Planning Commission Meeting Agenda
Hartland Township Hall
Thursday, August 12, 2021
7:00 PM

Hartland Township Planning Commission Meeting Agenda Memorandum

Subject: Site Plan #21-012 Hartland Crossing Planned Development (PD) Concept Plan

Date: July 29, 2021

CONCEPTUAL OUTLOT & MULTI-FAMILY PLAN

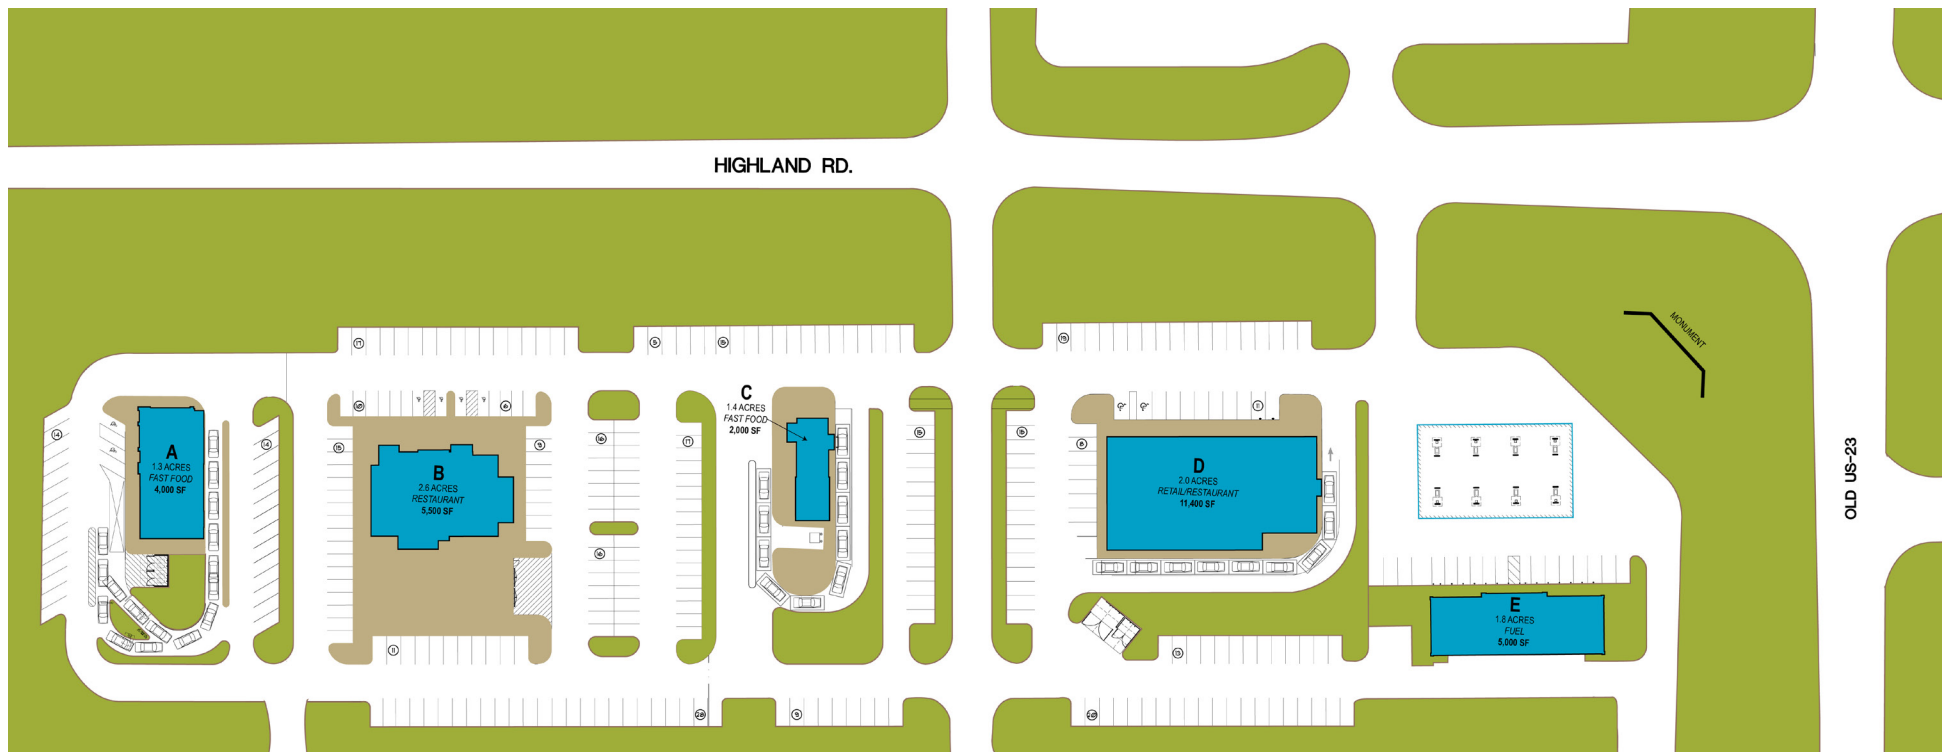
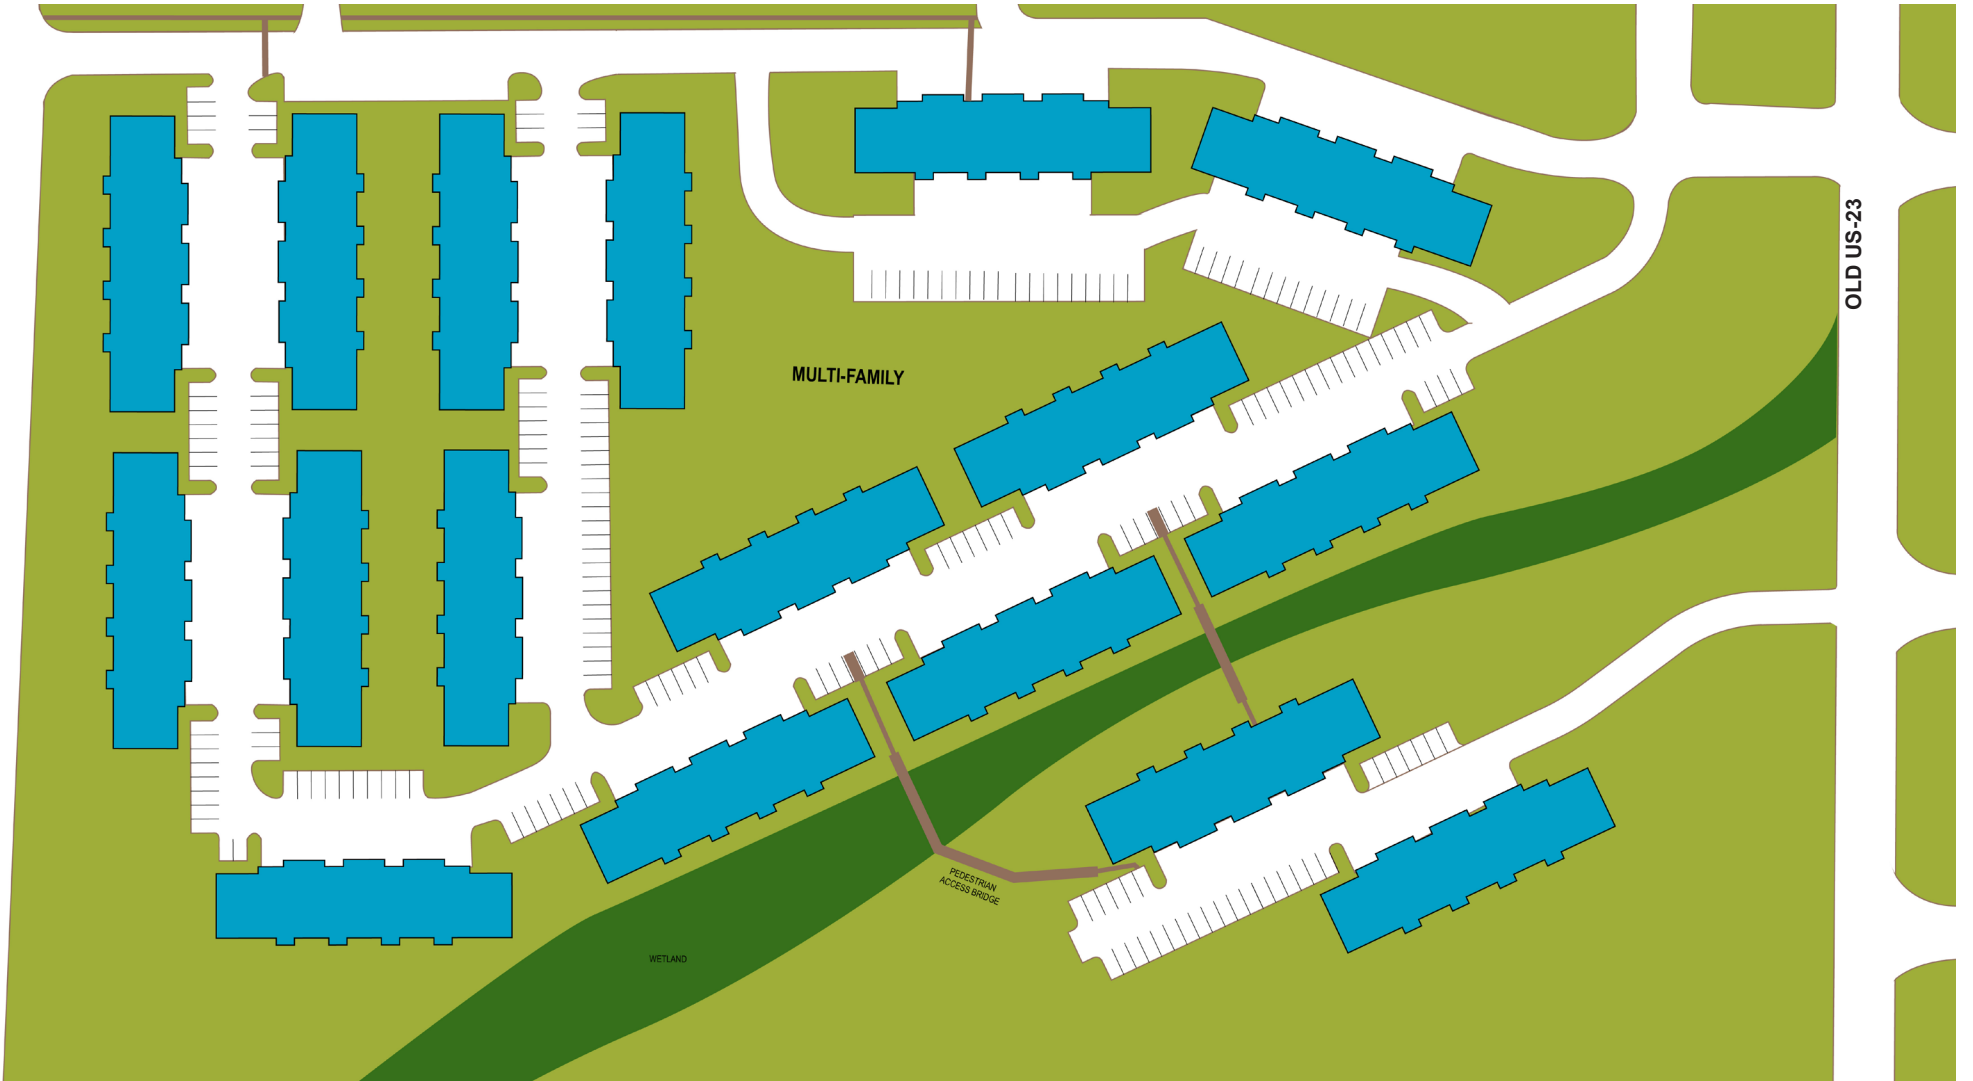
The applicant has submitted a Concept Plan for a mixed use planned development with commercial and residential uses. The site plan is not drawn to scale. The commercial uses are grouped along the northern portion of the site, with access provided from the Highland Road entrance. The entrance drive from Highland Road travels south and connects to the east-west internal road. Once one enters the site, internal drives provide circulation to each business and associated parking, as well as access to the residential portion of the site to the south.

The plan shows five (5) conceptual outlots which are meant to be place holders for future businesses. The plan does not state the overall size of the commercial area or for any outlot. The plan is not intended to be the final site plan for the commercial portion of the site. The following businesses/uses are shown, as possible options: two (2) fast food restaurants each with drive-through service; one (1) dine-in restaurant; one (1) multi-tenant building (restaurant and retail); and one (1) automobile fueling station. Other uses may be proposed once the project is further along in the PD process.

The multi-family/residential component of the PD occupies approximately the southern two-thirds of the PD site. A total of seventeen (17) residential buildings are shown, with fifteen (15) buildings located between the east-west internal access road and the wetland area on the south.

Two (2) buildings are located south of the wetland area, which appear to be similar in design to the multiple-family structures to the north. The two (2) buildings on the south can only be accessed via the most southern development entrance on Old US-23. An internal vehicular connection between the north and south residential areas is not provided however two (2) pedestrian bridges over the wetland area are shown. The applicant has noted that alternate uses could be considered for these two buildings such as a daycare facility, medical offices, or a hotel. All proposed uses in the commercial or residential areas of the PD must be compliant with those permitted under the GC-General Commercial zoning standards.

Conceptual building elevations of the residential buildings are provided as well as a conceptual depiction of a common recreation area, presumably for the residents in the PD. The architectural renderings show two-story residential buildings comprised with a mix of building materials (siding and stone products). The number of apartment/residential units is not stated. Building elevations were not provided for the commercial buildings.

Internal sidewalks throughout the development or along Highland Road and Old US-23 are not shown. Two (2) pedestrian access bridges are shown on the southern portion of the site. These bridges provide pedestrian connectivity between the two (2) residential areas.

The Township Engineer (HRC) noted that the next set of plans should show sidewalks along Highland Road and Old US-23, as well as stormwater detention areas.
